Work Order ID 137845

Item ID: D5162-041 Accept ***N900040100*** Setup Start ***NS1***
Revision ID: Stop ***NS2***
Item Name: Seat Structure Assembly
Start Date: 10/13/2015 Start Qty: 1.00 ***1*** Cust Item ID:
Required Date: 10/23/2015 Req'd Qty: 1.00 ***1*** Customer:
Reference:

DRAWING NO. D3016	TITLE SEAT FRAME ASSEMBLY	REV. A	DART AEROSPACE LTD ENGINEERING ORDER	D.E.O. NO. D3016-A-1	SHEET NO. SHEET 1 OF 1	SCALE NTS
DRAWN <i>J</i>	CHECKED <i>JP</i>	MFG. APPR. <i>RE</i>	APPROVED <i>WAP</i>	DE APPR. <i>WAP</i>		
DATE 10.01.29	DATE 10.01.29	DATE 10.01.29	DATE 10.01.29	DATE 10.01.29

PURPOSE:

D3016-11 SADDLE

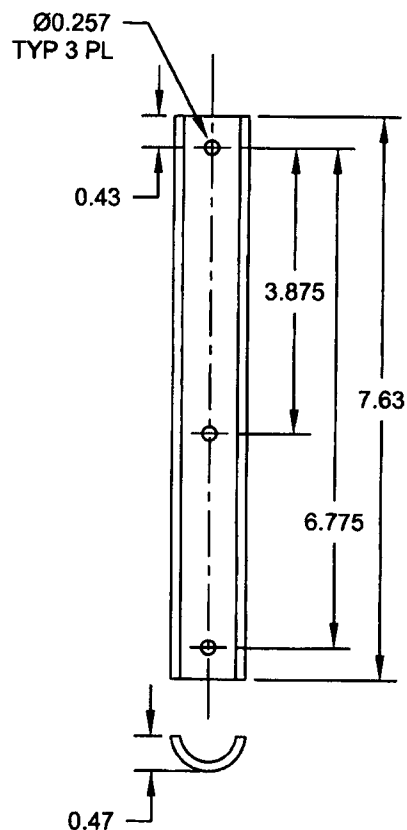
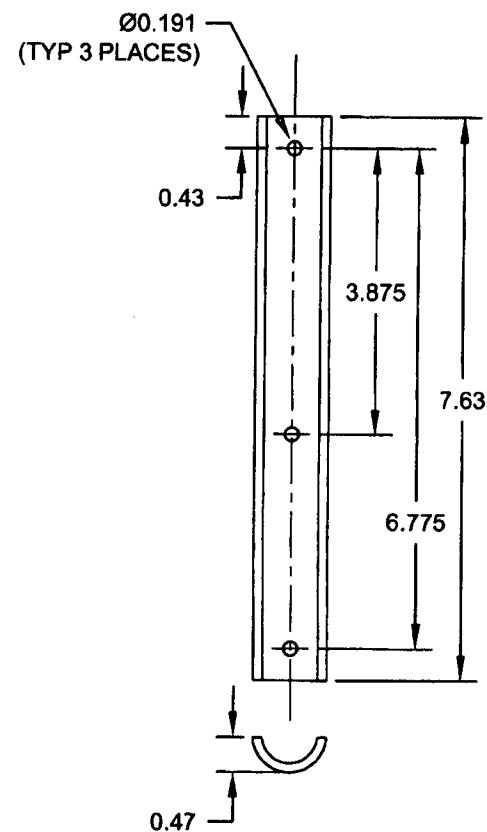
TO REVISE D3016-11 SADDLE'S HOLE SIZES

DETAIL D3016-11 SADDLE (SHEET 3): Ø0.257 TYP 3 PL WAS Ø0.191 (TYP 3 PLACES) AS SHOWN:
